Area Walk-By Checklist (AWC)

Area 1AB-1g Floor El. 574 Bldg. AX

File Name: 1-65-3-1-18.jpeg
Description: View of temporary equipment restrained

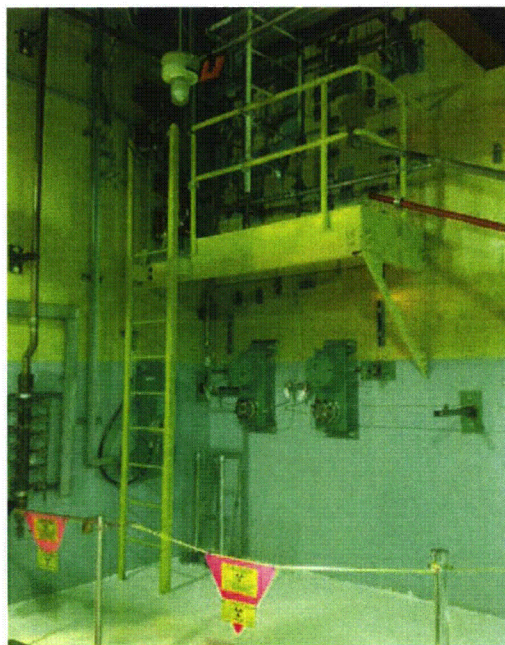
Barrier and welding machine adequately restrained. Temporary scaffolding in area judged to be adequately restrained

File Name: 1-59-3-1-20.jpeg
Description: View of scaffold staging area

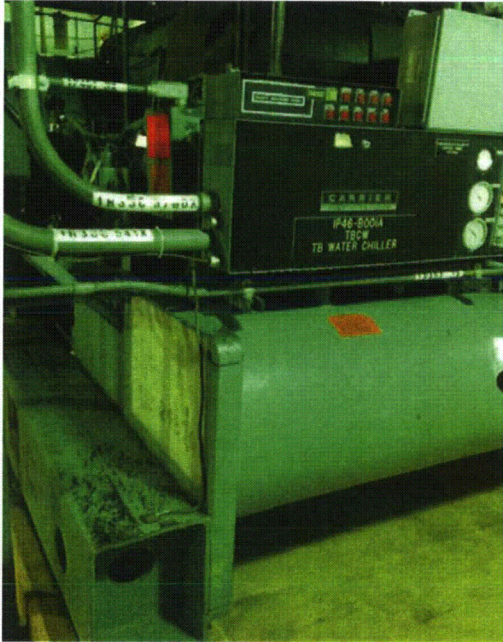
Scaffold staging area is adjacent to CAT-1 panel 1H51P0037. Potential for equipment or pieces of scaffold to slide into panel. CR 2012-12375 generated to document this situation.

File Name: 1-67-3-1-20.jpeg
Description: View of IP46B001A water chiller in the area

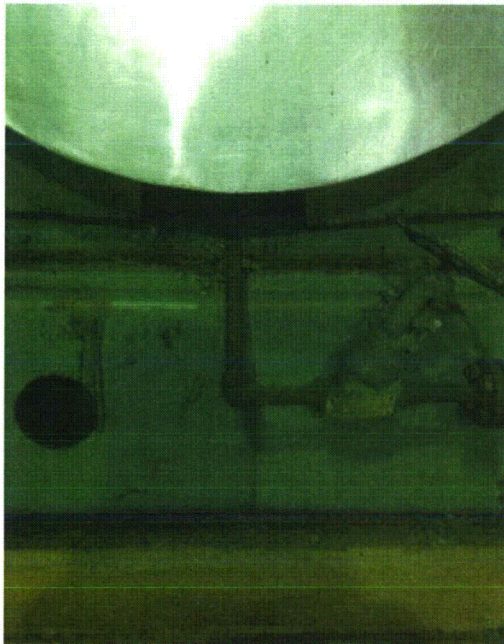
TB Chillers 1P46-B001A and 1P46-B001B are very large double stack chillers anchored with only four 3/4" anchor bolts on a ~16" wide x ~6" high pedestal. These chillers are not category I and anchorage may not be adequate for seismic loading. Judged acceptable because the chillers have a limited water supply and would not impact or flood any CAT-1 components if they should fail.

Description: View of corroded bolt located north east end of 1P46B001B

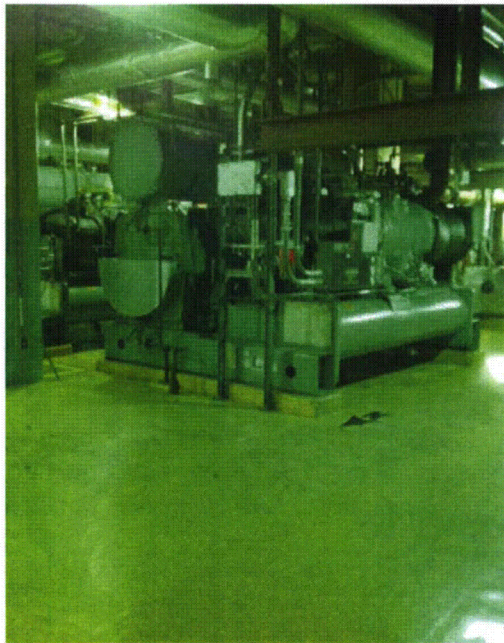
Anchorage for TB chillers identified with significant corrosion. This is judged to be acceptable, as described in comments for Question 1.

File Name: 1-60-3-1-14.jpeg
Description: Scaffold structure for chiller unit

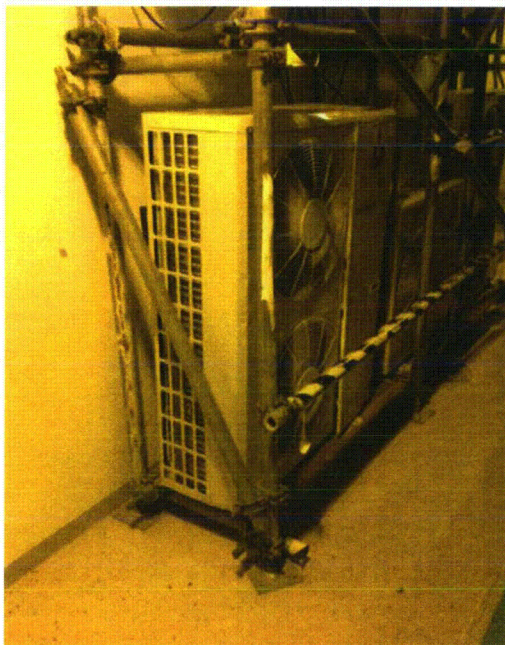
Scaffold structure identified as being used as a support system for a Chiller Unit. Falling of the scaffold on the nearby MOV judged not a concern since it will not induce a significant damage to the valve or nearby pipe lines. However, a condition report (CR 2012-12373) was issued to address an unauthorized modification to the plant for a chiller unit.
